Additions and Renovations
Platt Technical High School
Milford, CT

ADDENDUM NO. 3

August 2, 2019

1 FIRST FLOOR PLUMBING BELOW SLAB - AREA B
1/8" = 1'-0"

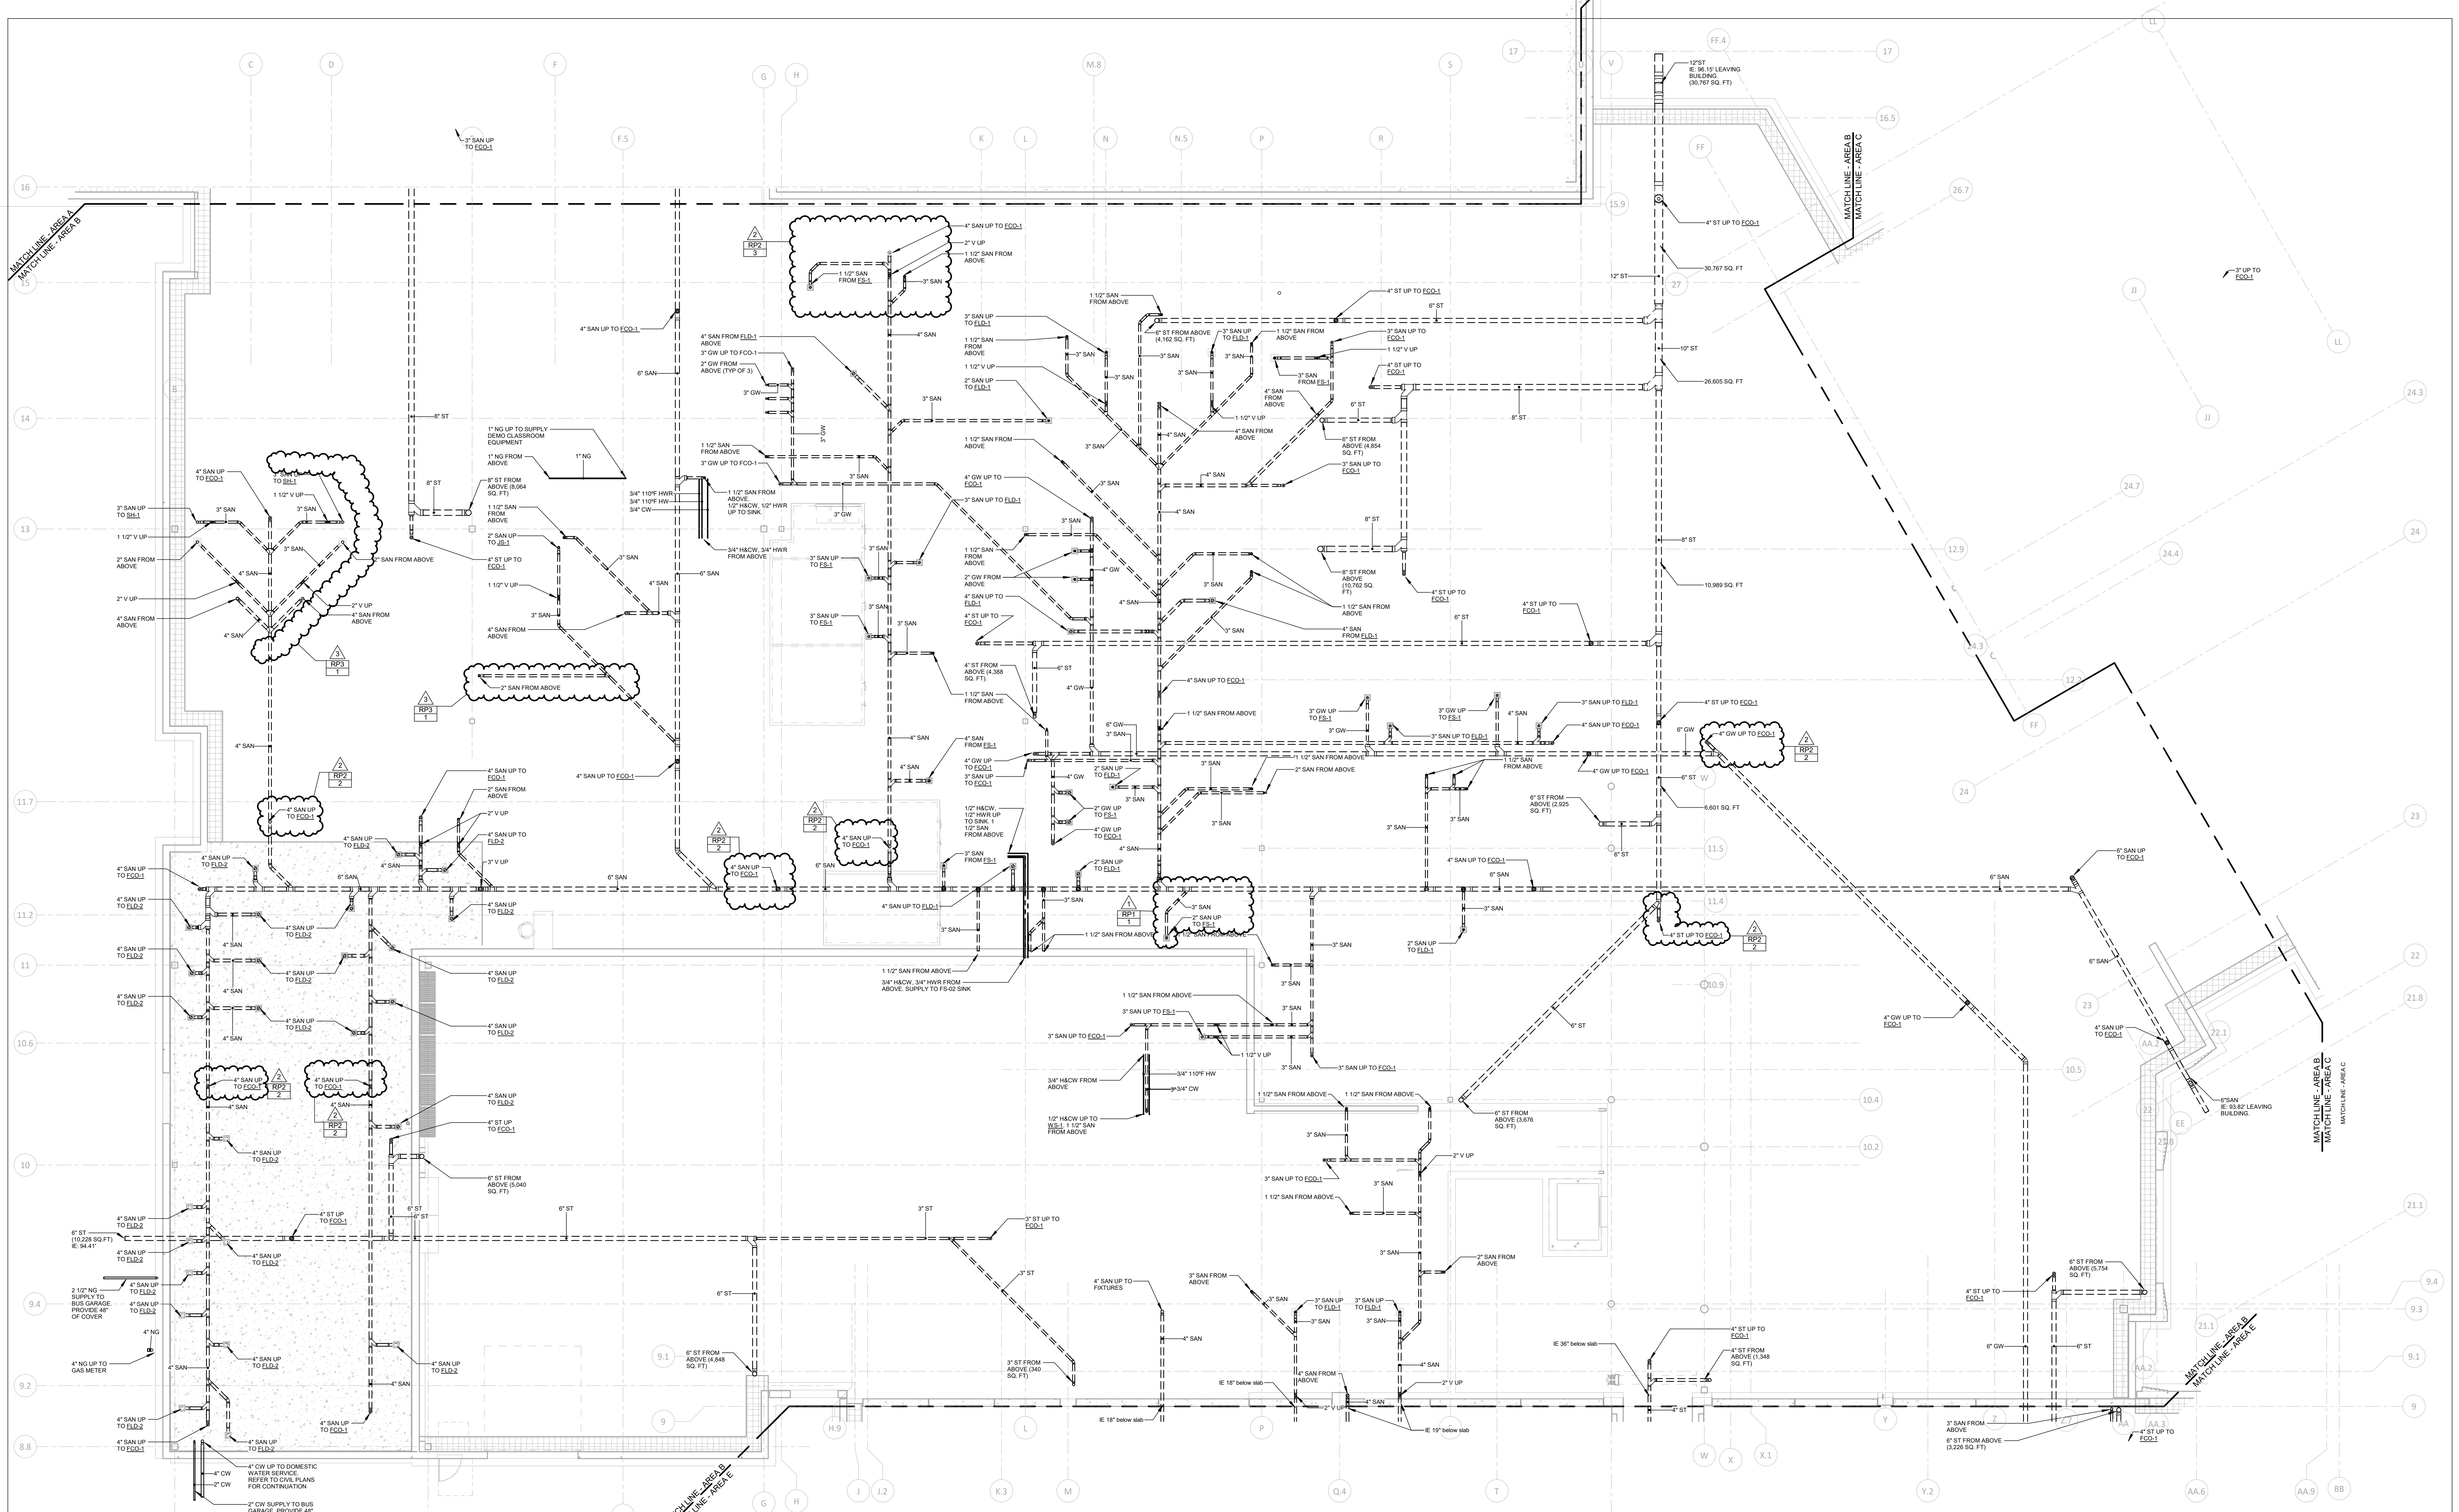
ADD 3-079 DRAWING P-1-UB – UNDERSLAB PLUMBING PLAN AREA B
Removed washer and dryer electrical connections from Laundry/Storage B116 and relocated to Recycle Room B115 per Revision RP3-1.

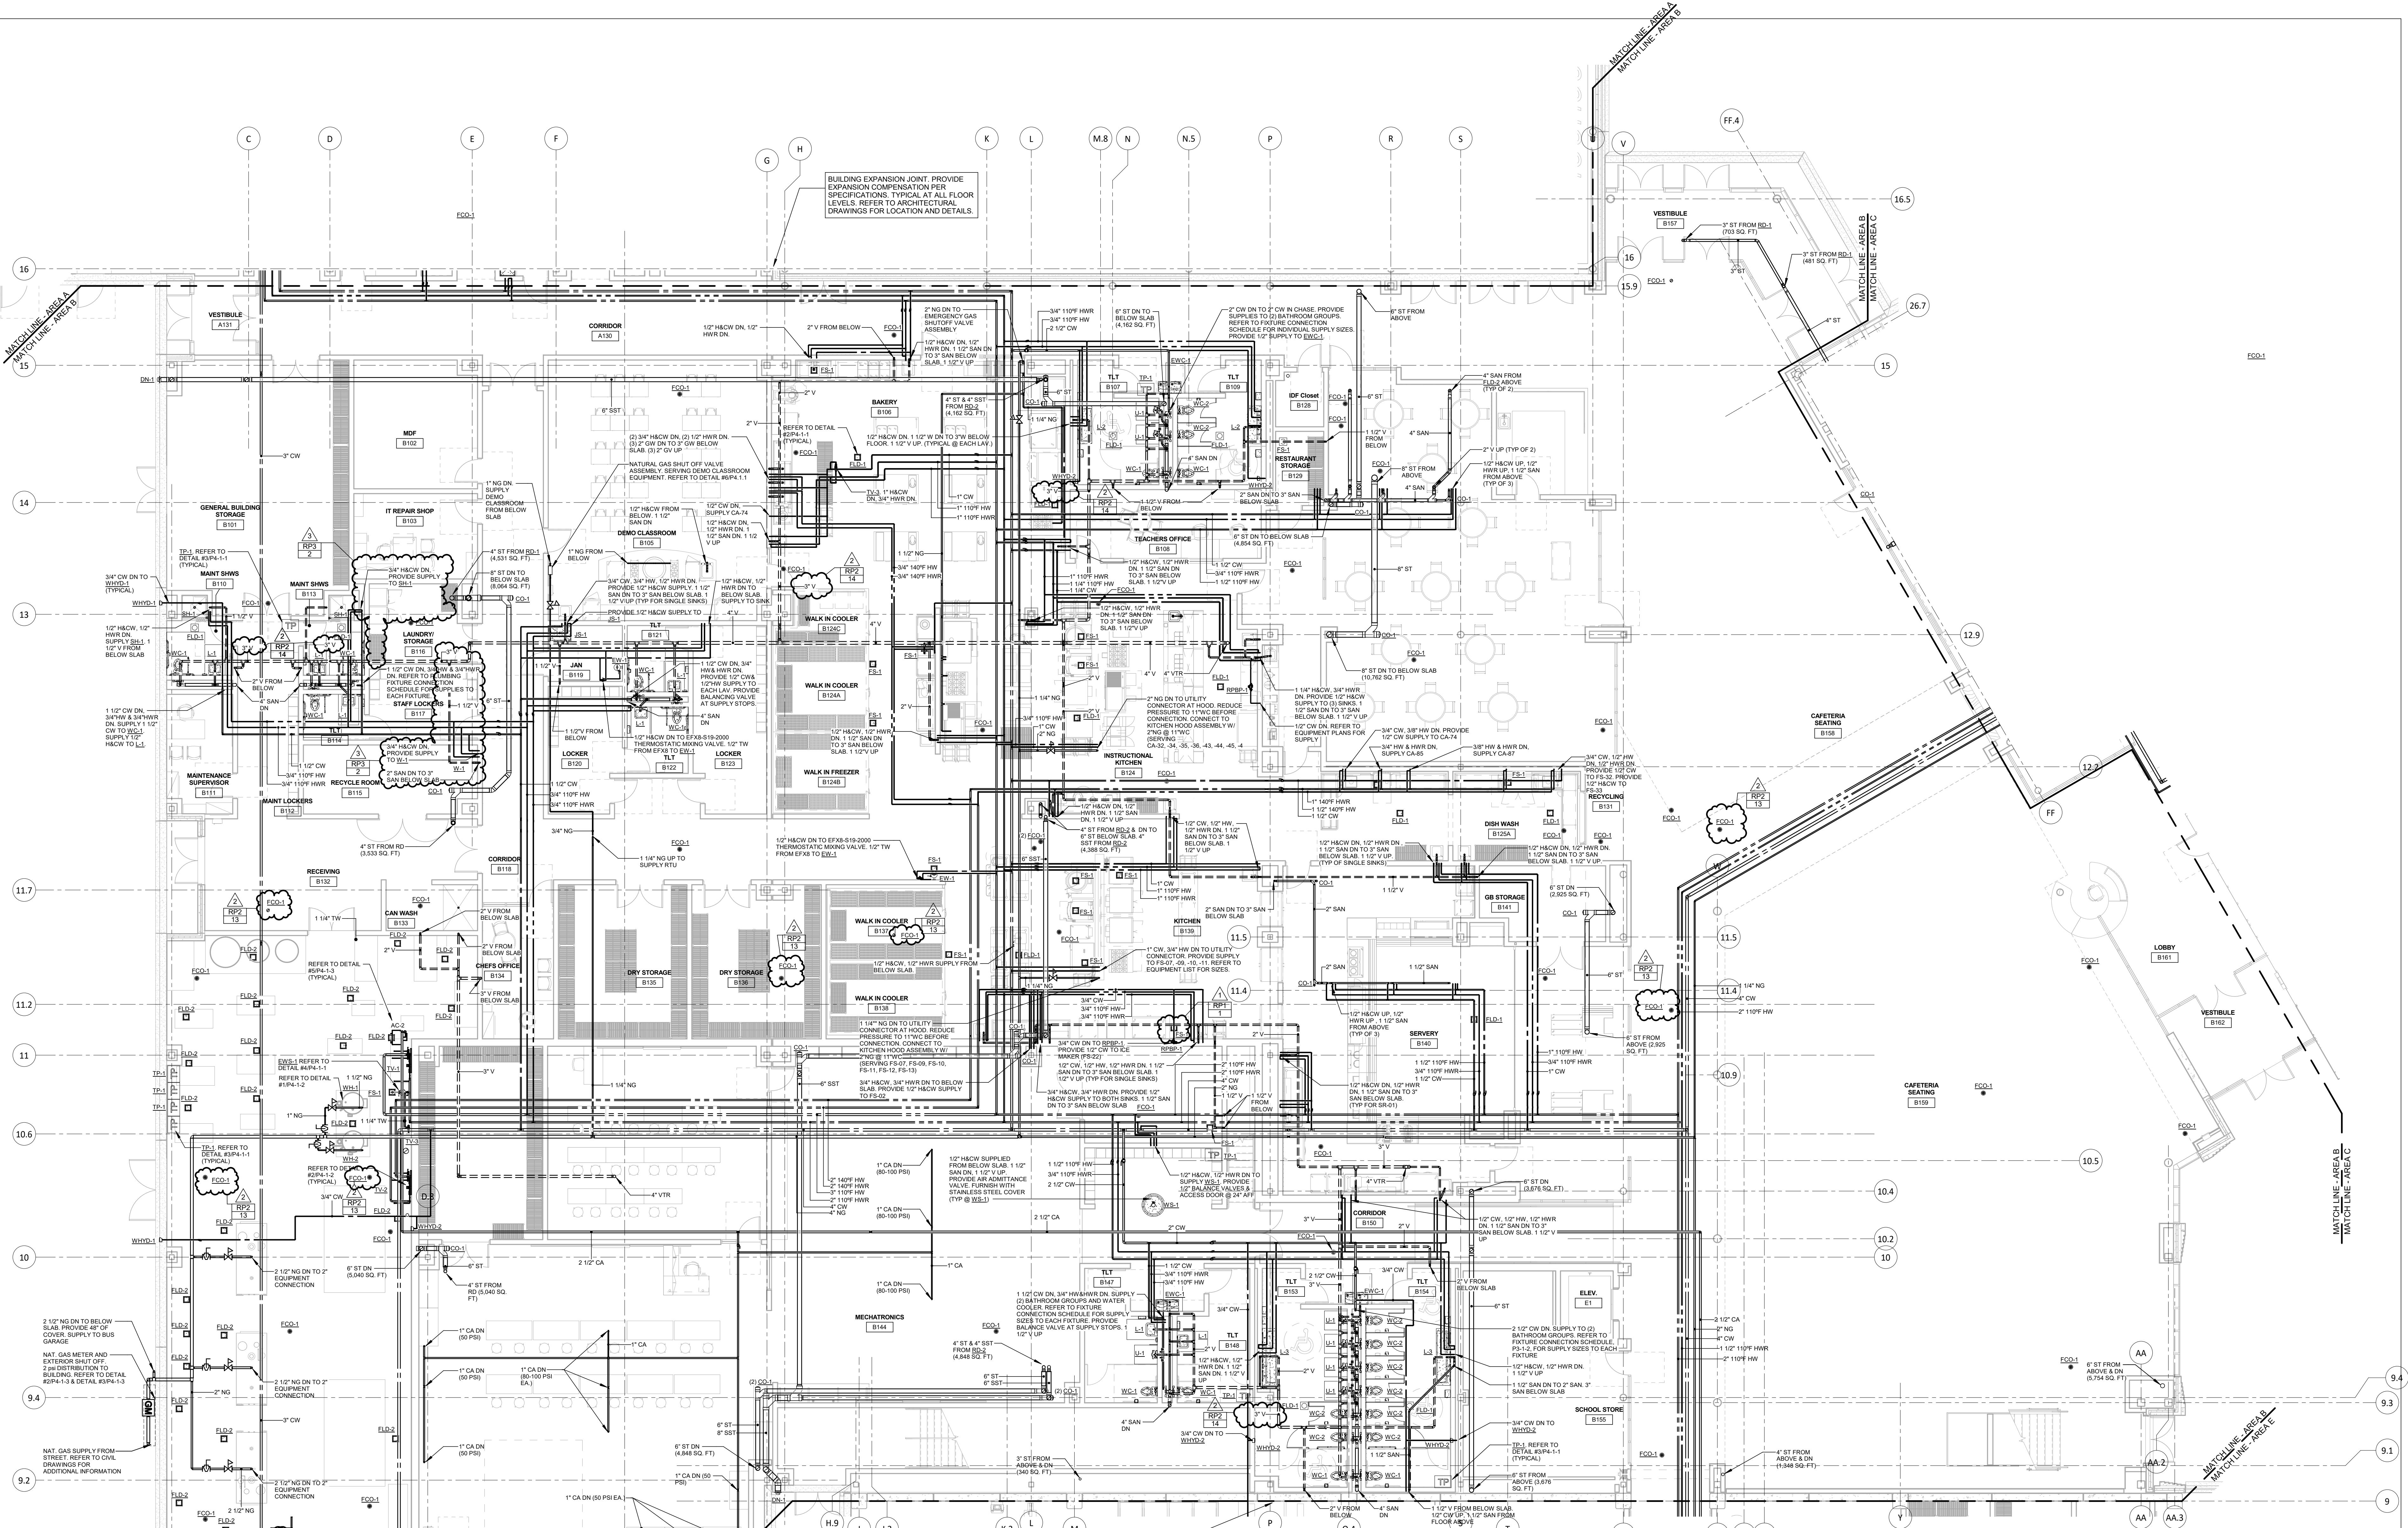
ADD 3-080 DRAWING P-1-1B – FIRST FLOOR PLUMBING PLAN AREA B
Removed washer and dryer electrical connections from Laundry/Storage B116 and relocated to Recycle Room B115 per Revision RP3-2.

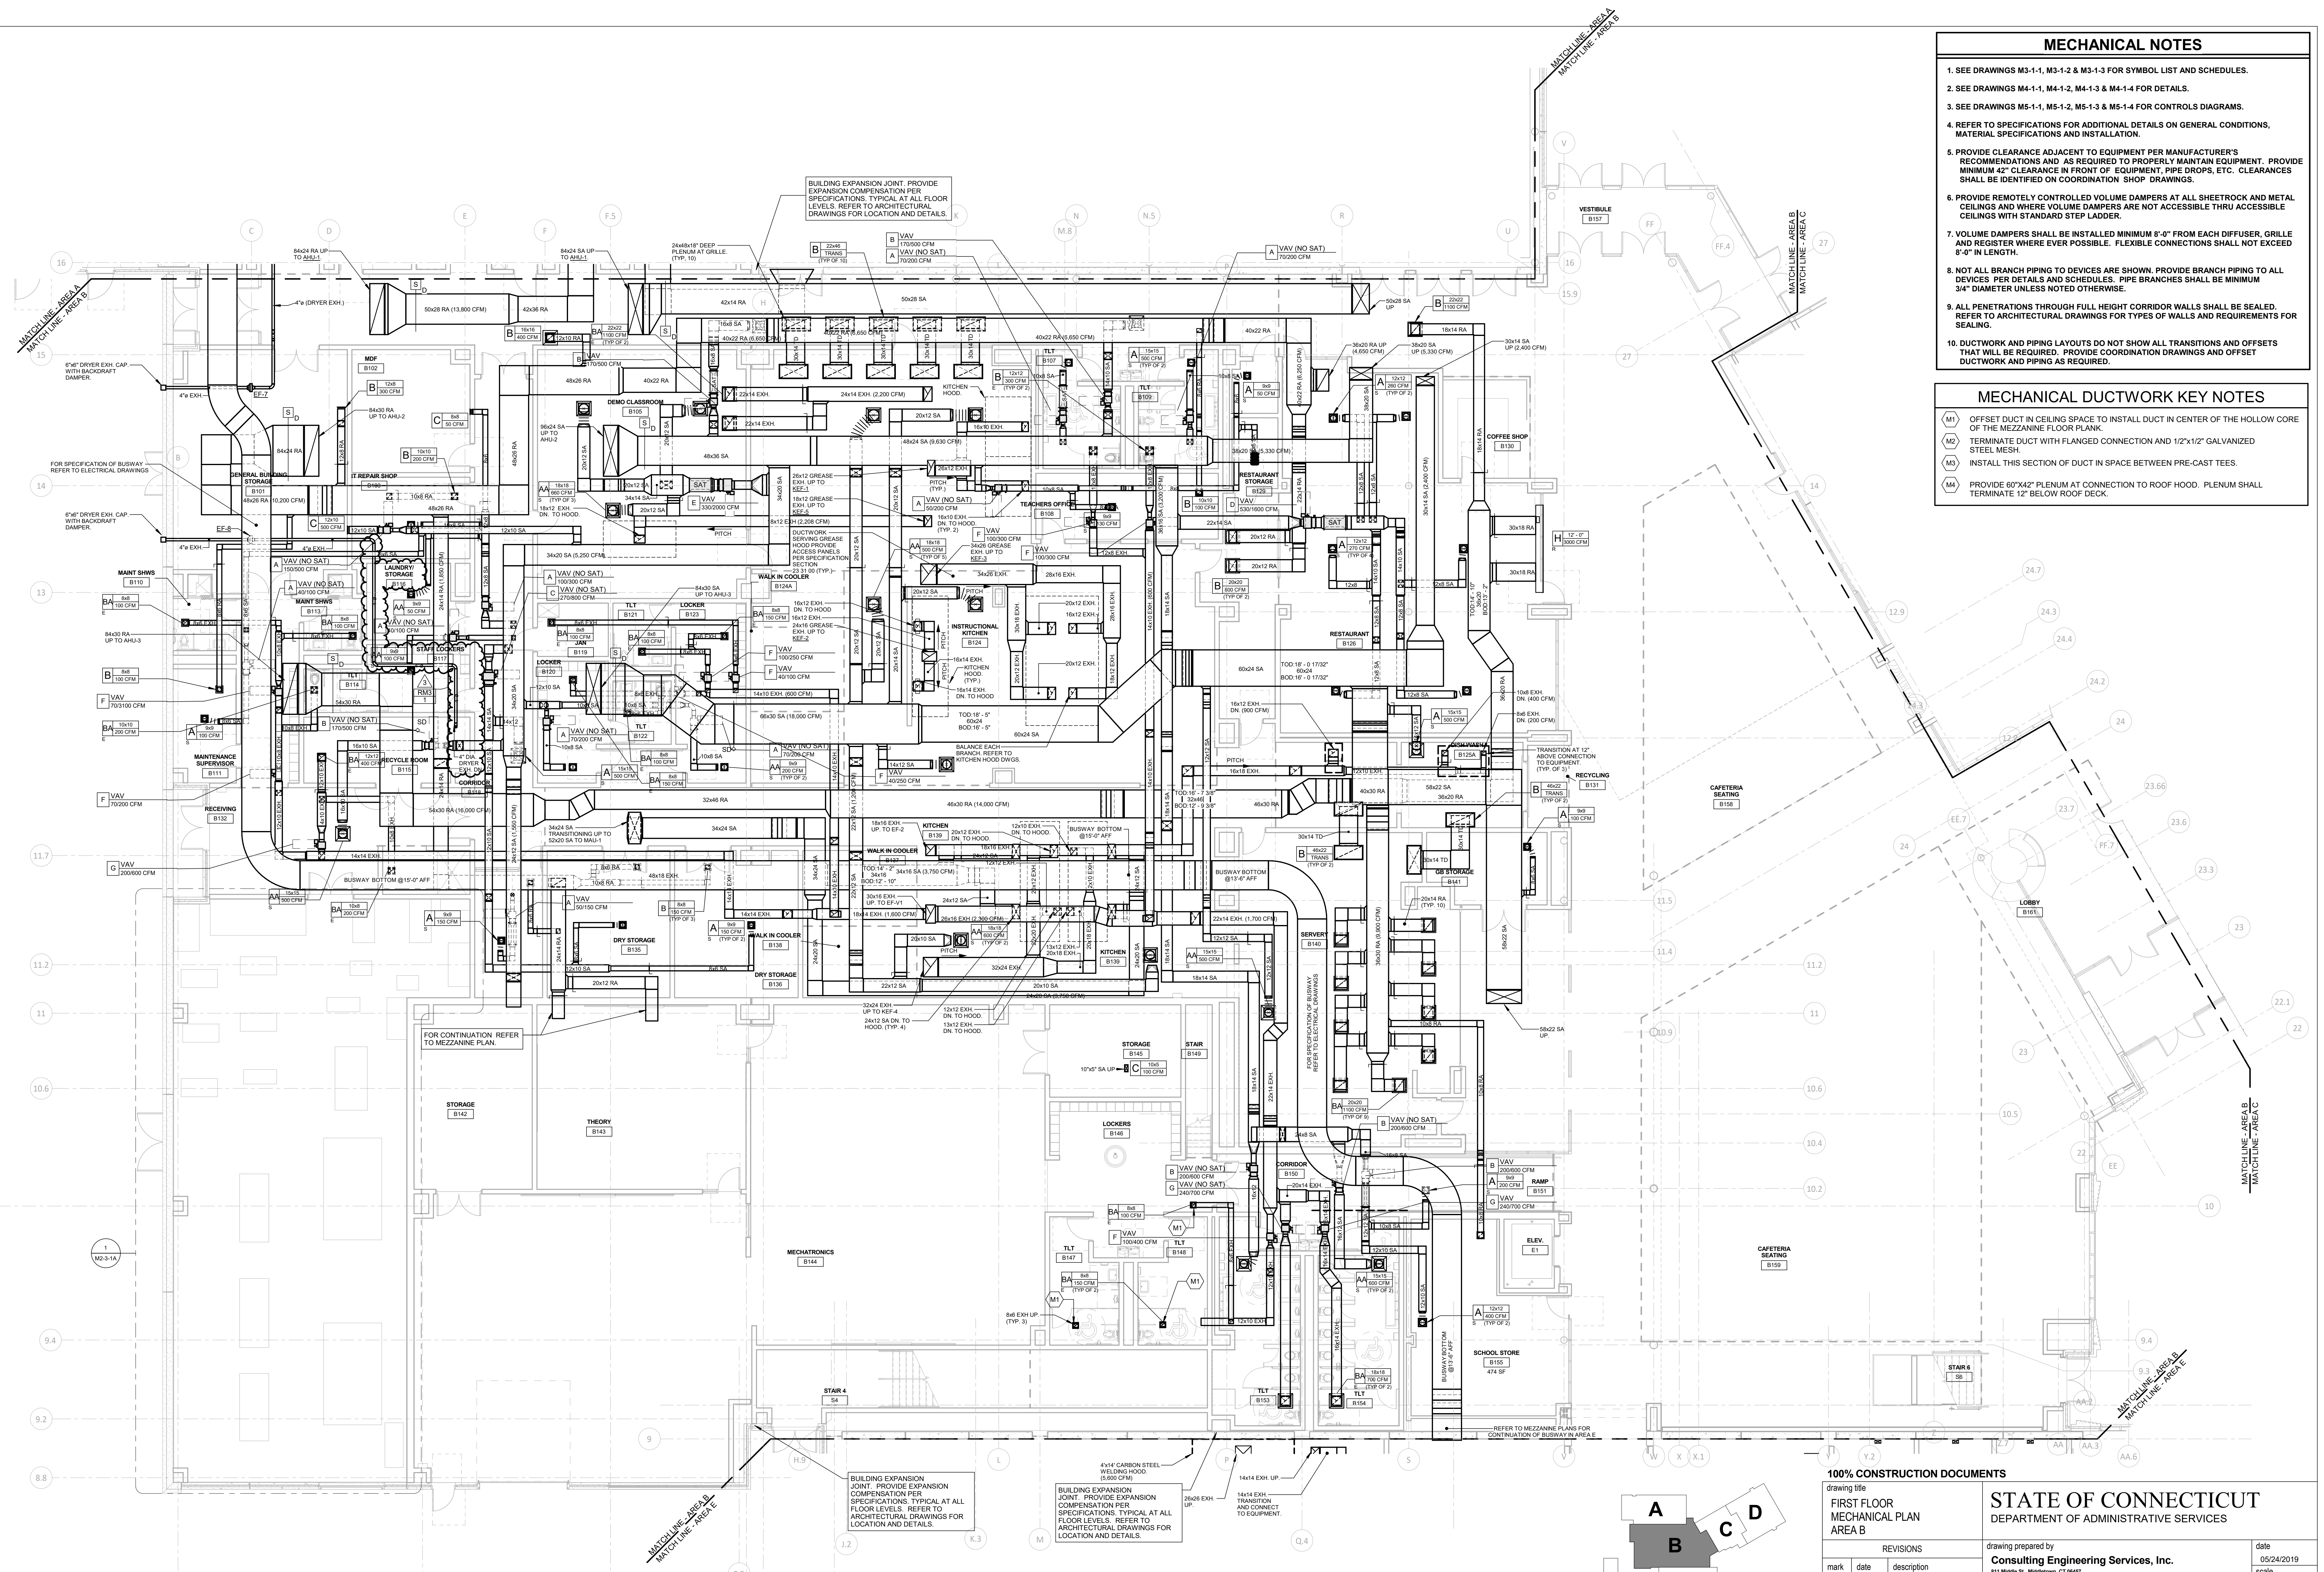
ADD 3-081 DRAWING M-1-1B – FIRST FLOOR MECHANICAL PLAN AREA B
Removed dryer duct connection from Laundry/Storage B116 and relocated to Recycle Room B115 per Revision RM3-1.
